Access Compliance Report

Public Rights-of-Way

Intersection ID: 17739	Main Street: E_WOODLAWN_RD	Cross Street: SOUTH_BV	Location: SE
ADA ID: F1349A006DAD	Ramp Type: Perp	Initial Pass/Fail: Fail	Overall Compliance: No
Severity Score: 13.75			
Codes/Mitigation Info/Possible Solution		Field Measurements/Component Compliance

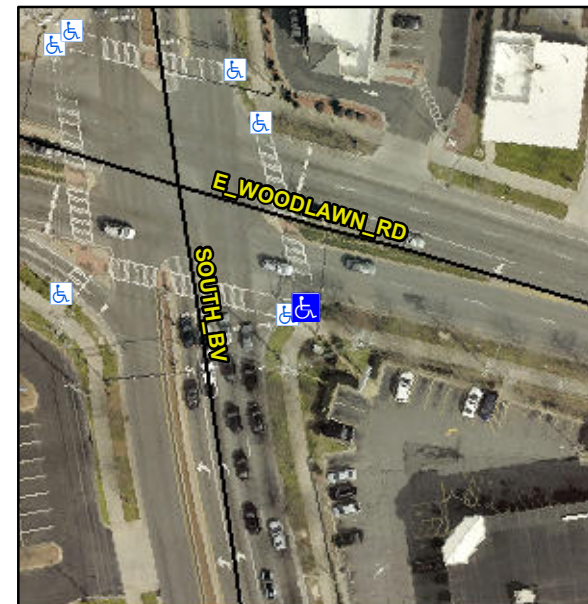
R304.2.2

Compliance	Description	Data	Compliance	Description	Data
N/A	Ramp Length (in)	98.0	No	Ramp Slope (%)	9.5
Yes	Ramp Width (in)	72.0	Yes	Ramp XSlope (%)	3.9
N/A	Flare Type LT	N/A	N/A	Flare Type RT	N/A
N/A	Flare Slope LT (%)	N/A	N/A	Flare Slope RT (%)	N/A
N/A	Flare Traversable LT?	N/A	N/A	Flare Traversable RT?	N/A
N/A	Landing Length (in)	N/A	N/A	DWS Provided?	N/A
N/A	Landing Width (in)	N/A	N/A	DWS Contrast?	N/A
N/A	Landing Slope (%)	N/A	N/A	DWS Length (in)	N/A
N/A	Landing X Slope (%)	N/A	N/A	DWS Full Width?	N/A
N/A	Landing Curb? (Y/N)	N/A	N/A	DWS Offset (in)	N/A
N/A	Shared Landing?	N/A			
N/A	Gutter Ponding?	N/A	N/A	Gutter Slope (%)	N/A
N/A	Gutter Lip Ht (in)	N/A	N/A	Gutter X Slope (%)	N/A
N/A	Painted X Walk1?	Yes	N/A	Painted X Walk2?	N/A
	X Walk 1 Direction	To NW		X Walk 2 Direction	N/A
N/A	X Walk 1 Width (in)	111.0	N/A	X Walk 2 Width (in)	N/A
	X Walk 1 Slope (%)	1.9		X Walk 2 Slope (%)	N/A
	X Walk 1 X Slope (%)	5.9		X Walk 2 X Slope (%)	N/A

Remove & Replace Entire Ramp.
